# **A G E N D A**

## **Architectural Review Board**

**May 23, 2023 – 5:30 p.m.**

1A

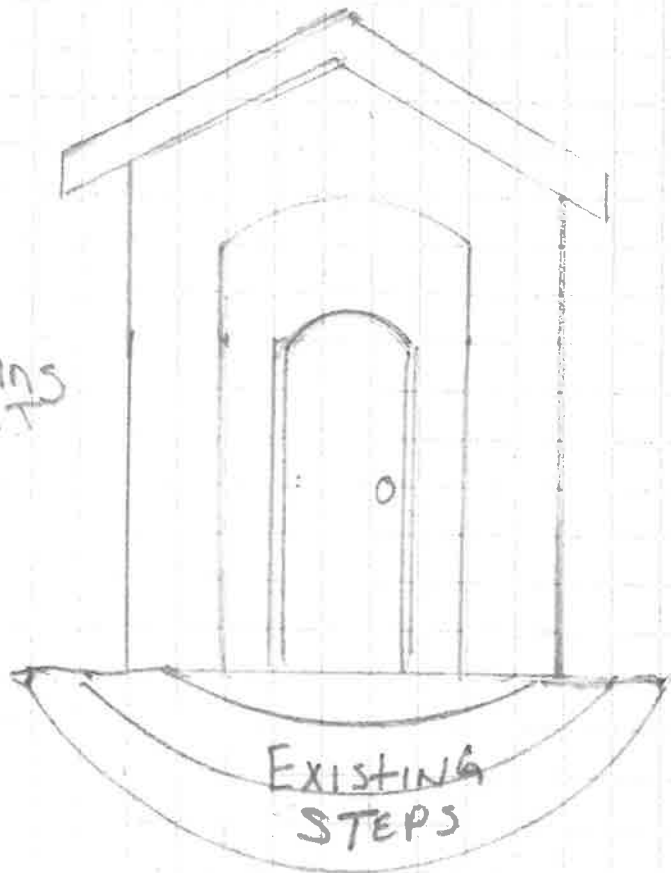
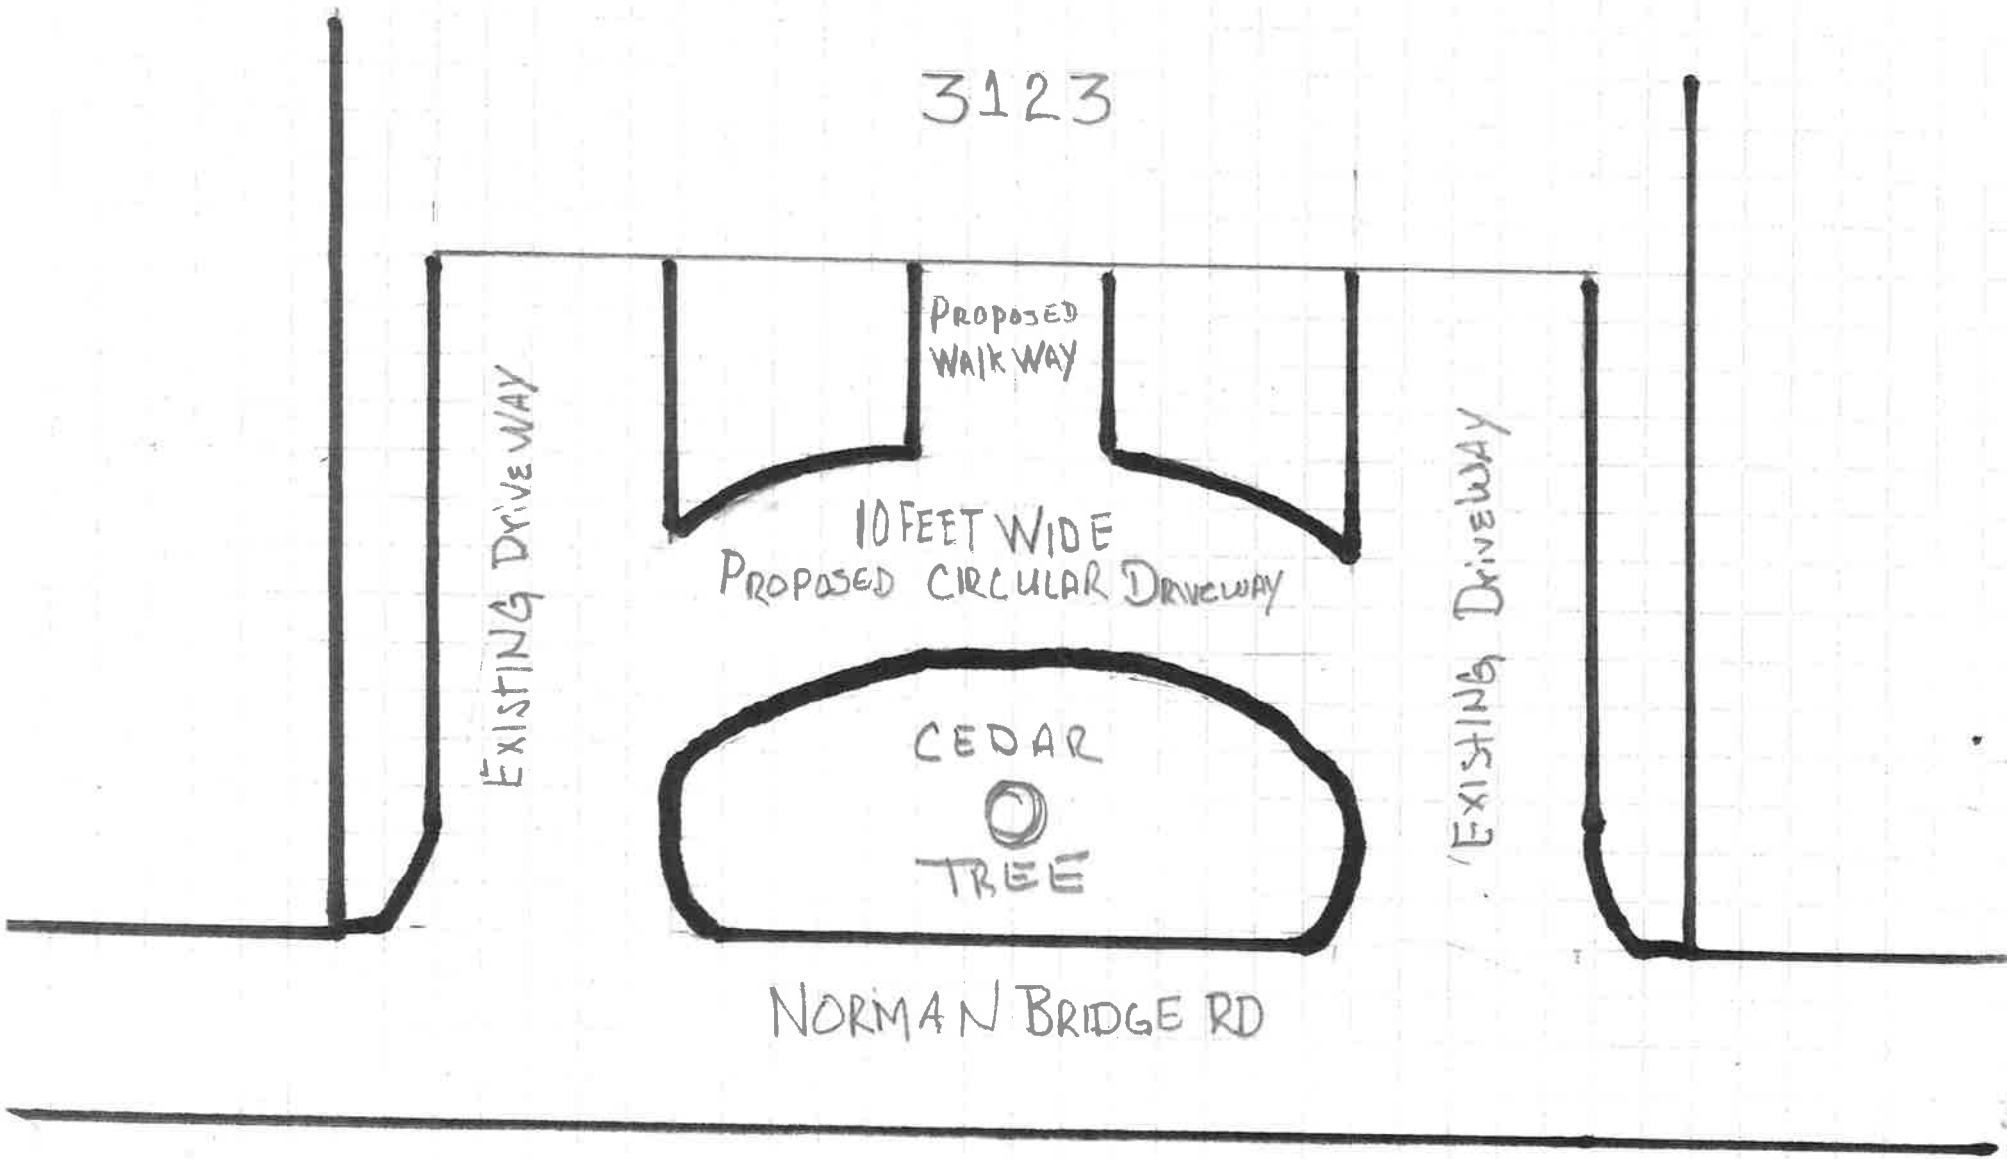
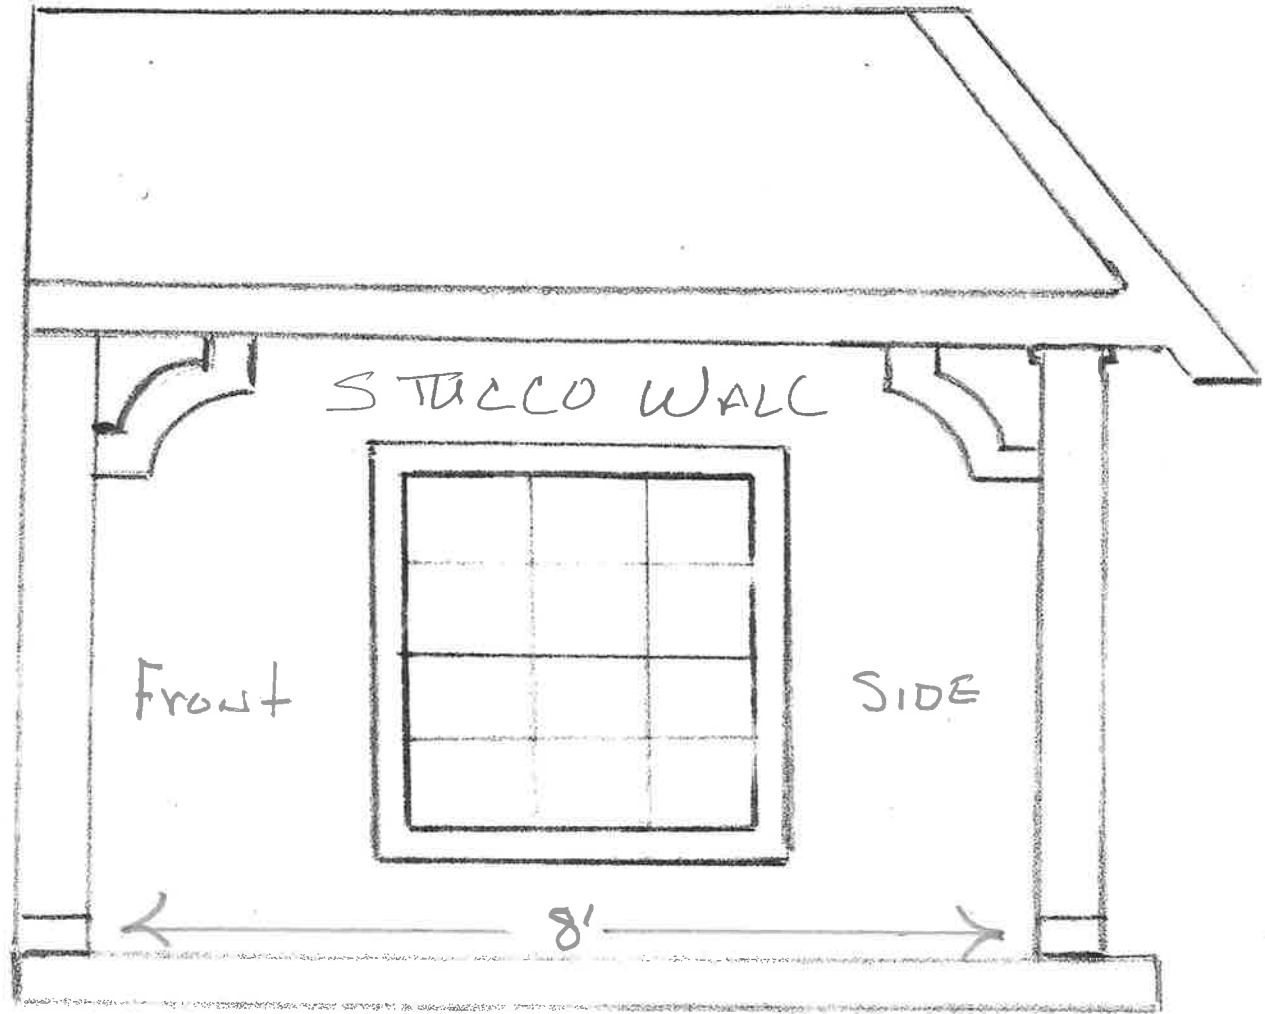
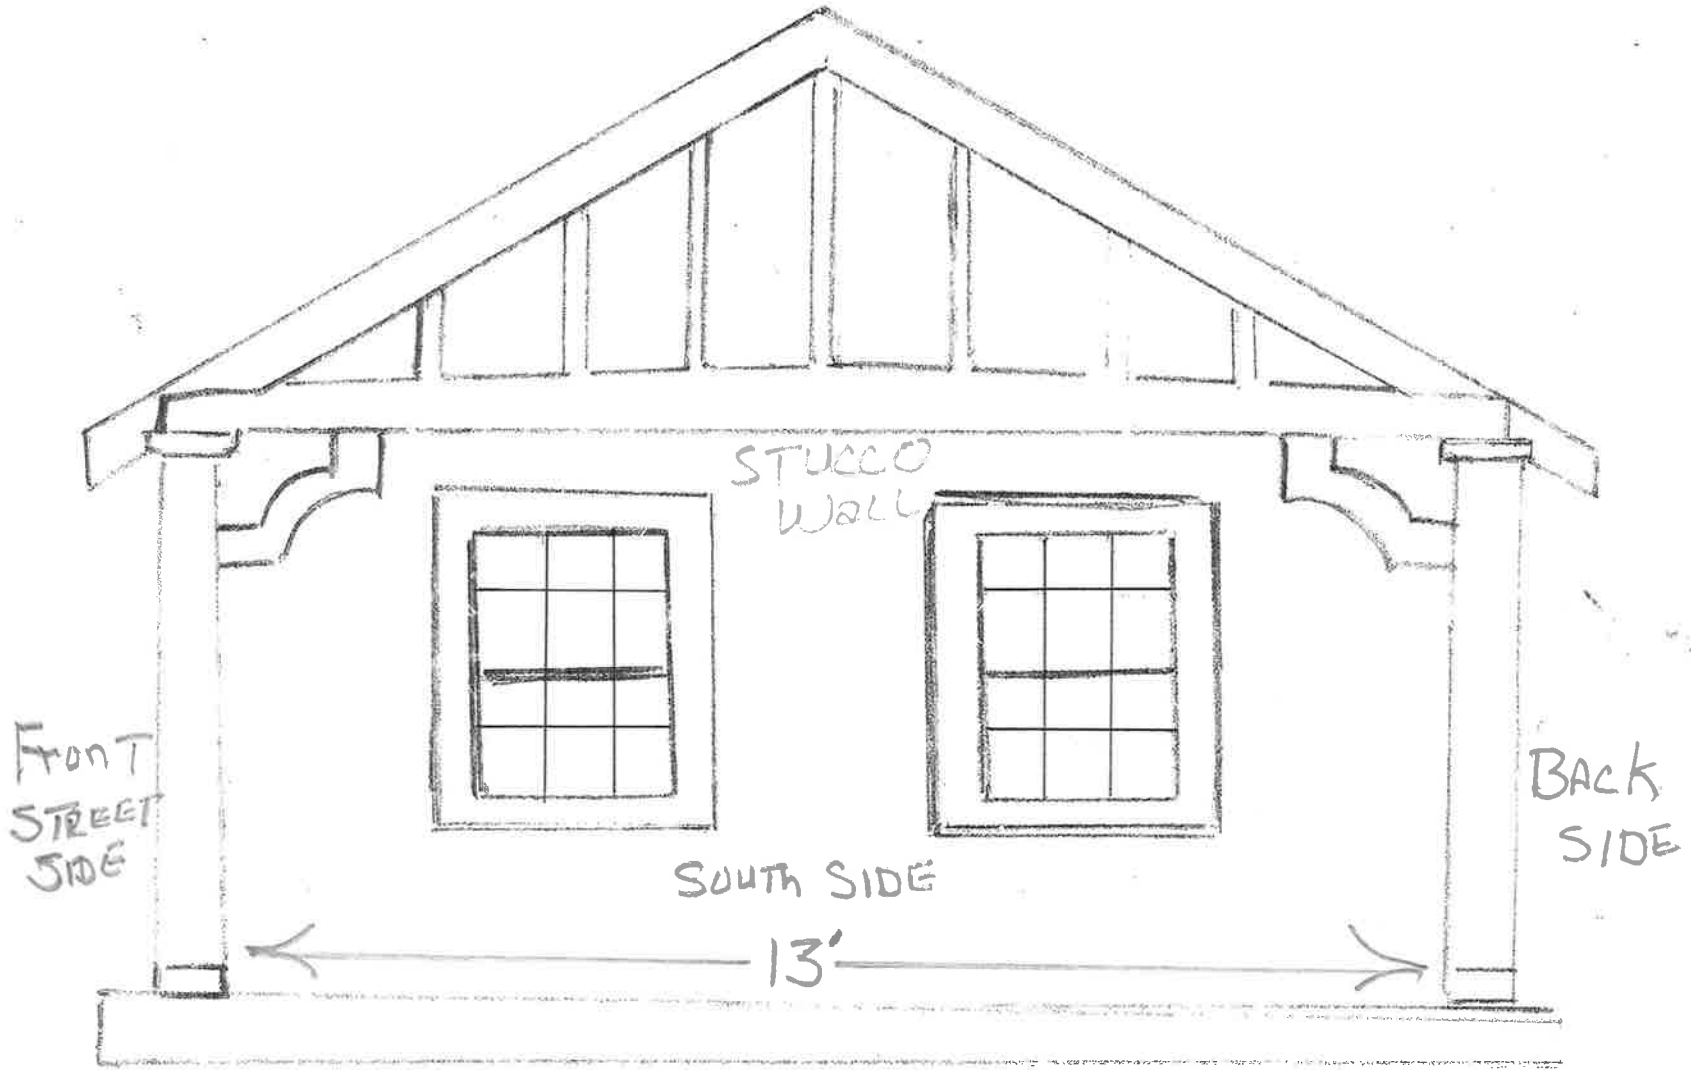
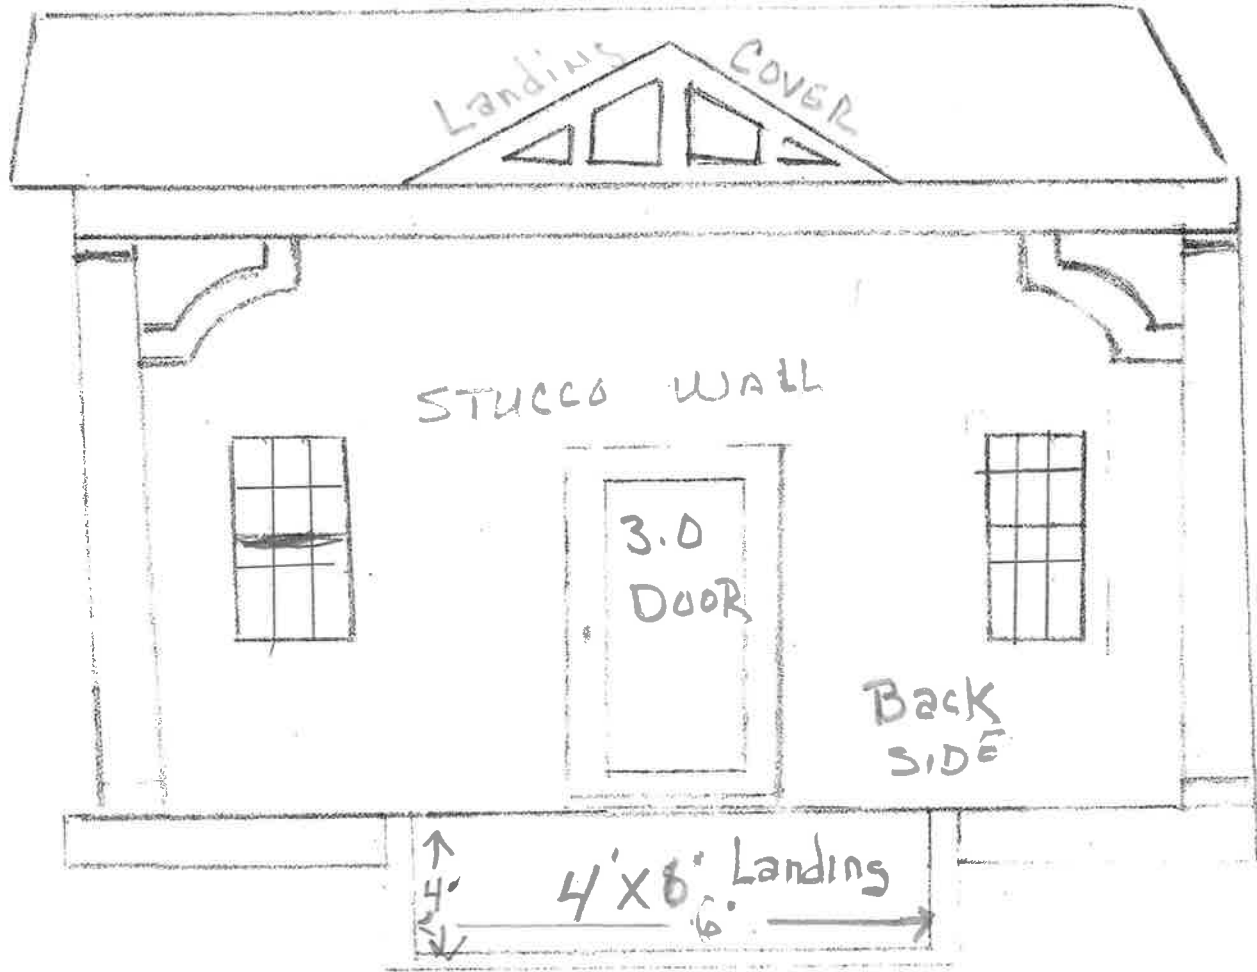
- The Board approved restoring the front windows and steps to their original design at the April 25, 2003, meeting.
- Perhaps a better plan would be to restore the front façade to the original design without the addition of the 4' stoop addition.
- The front yard is a historic character of the house. Since there is adequate room in the rear yard, we feel the parking is better suited there.
- It is good that the request keeps the original columns and brackets of the porch but a more sensitive design needs to be found to achieve your goal.

REQUEST FOR WINDOW REPLACEMENT

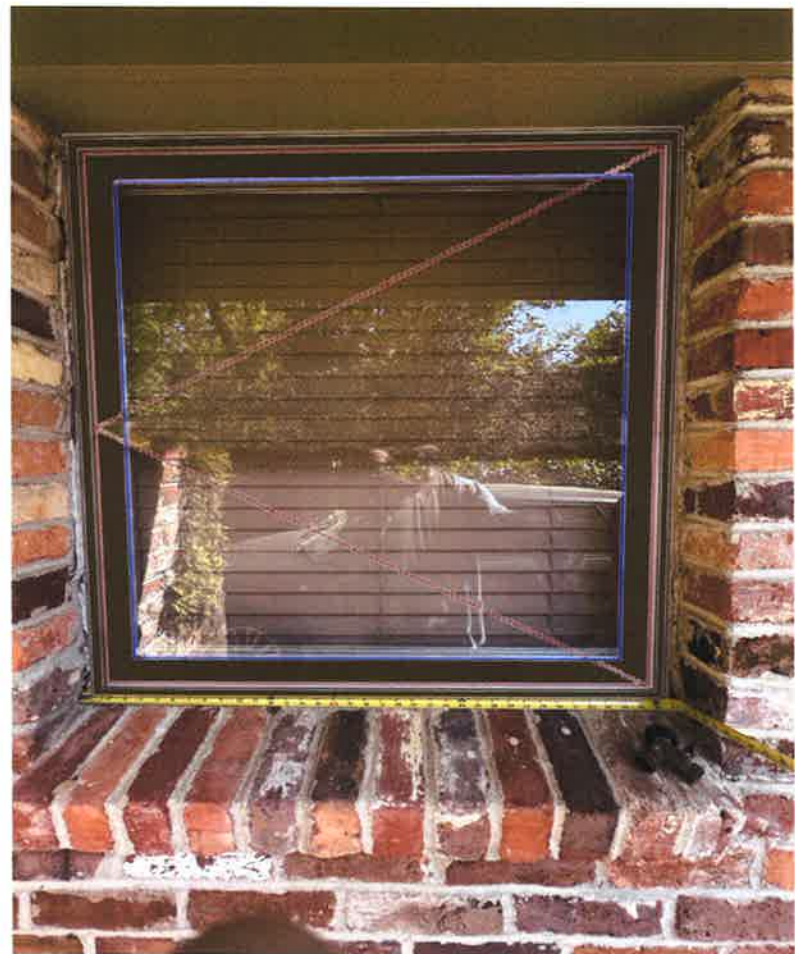
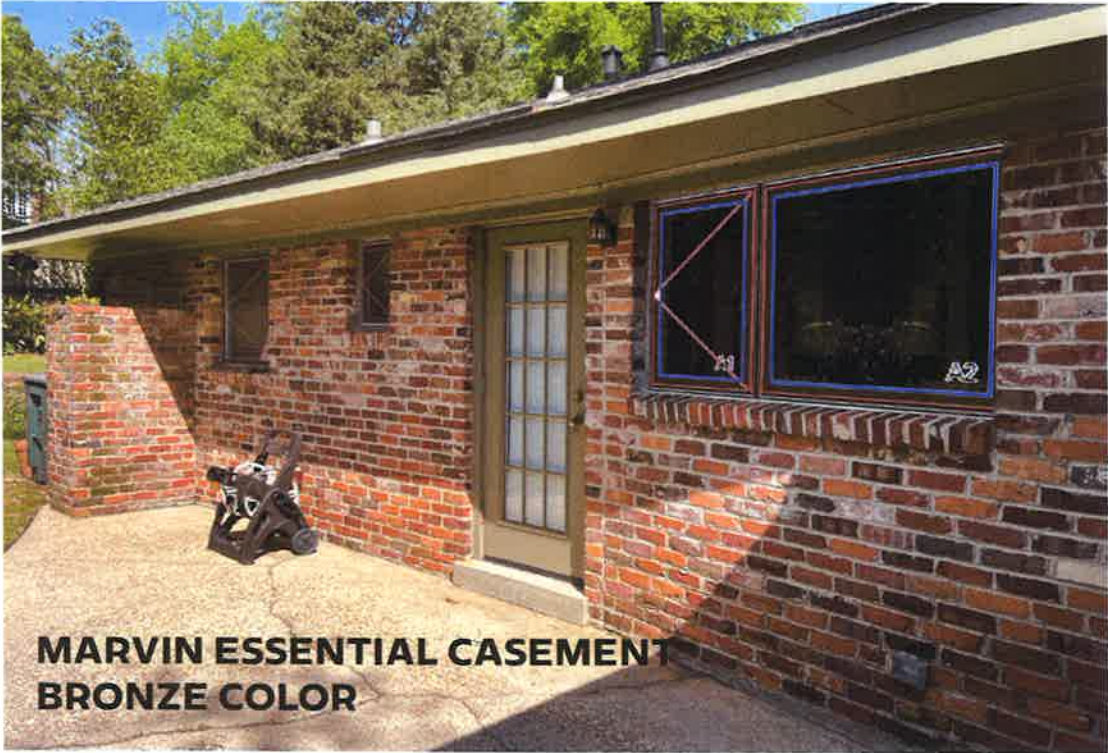
- Staff would like to see muttins applied to match current grid patters
- Staff would like to have the three (3) part windows to match in width to the existing windows.
